Access Compliance Report

Public Rights-of-Way (Curb Ramps)

Intersection ID: 43370	Main Street: SIMONTON_DR	Cross Street: SOBECK_LN	Location:	N
ADA ID: 4975191AF85F	Ramp Type: PerpDiag	Initial Pass/Fail: Fail	Overall Compliance: No	Severity Score: 13.75

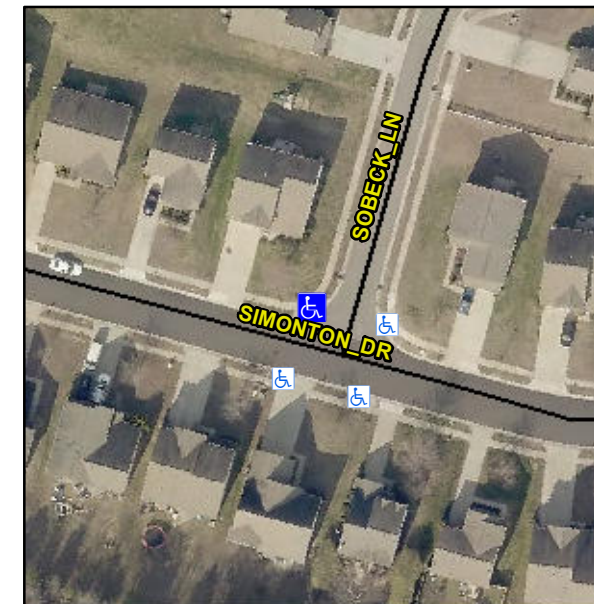
Not Found, R304.2.2, R304.5.3

Compliance	Description	Data	Compliance	Description	Data
N/A	Ramp Length (in)	45.0	No	Ramp Slope (%)	8.6
Yes	Ramp Width (in)	48.0	No	Ramp XSlope (%)	2.9
N/A	Flare Type LT	N/A	N/A	Flare Type RT	N/A
N/A	Flare Slope LT (%)	N/A	N/A	Flare Slope RT (%)	N/A
N/A	Flare Traversable LT?	N/A	N/A	Flare Traversable RT?	N/A
N/A	Landing Length (in)	N/A	N/A	DWS Provided?	N/A
N/A	Landing Width (in)	N/A	N/A	DWS Contrast?	N/A
N/A	Landing Slope (%)	N/A	N/A	DWS Length (in)	N/A
N/A	Landing X Slope (%)	N/A	N/A	DWS Full Width?	N/A
N/A	Landing Curb? (Y/N)	N/A	N/A	DWS Offset (in)	N/A
N/A	Shared Landing?	N/A			
N/A	Gutter Ponding?	N/A	N/A	Gutter Slope (%)	N/A
N/A	Gutter Lip Ht (in)	N/A	N/A	Gutter X Slope (%)	N/A
N/A	Painted X Walk1?	No	N/A	Painted X Walk2?	No
	X Walk 1 Direction	To SW		X Walk 2 Direction	To SE
N/A	X Walk 1 Width (in)	N/A	N/A	X Walk 2 Width (in)	N/A
	X Walk 1 Slope (%)	2.0		X Walk 2 Slope (%)	4.2
	X Walk 1 X Slope (%)	4.6		X Walk 2 X Slope (%)	0.2

Remove & Replace Curb Ramp With Two New Directional Ramps or Equivalent.
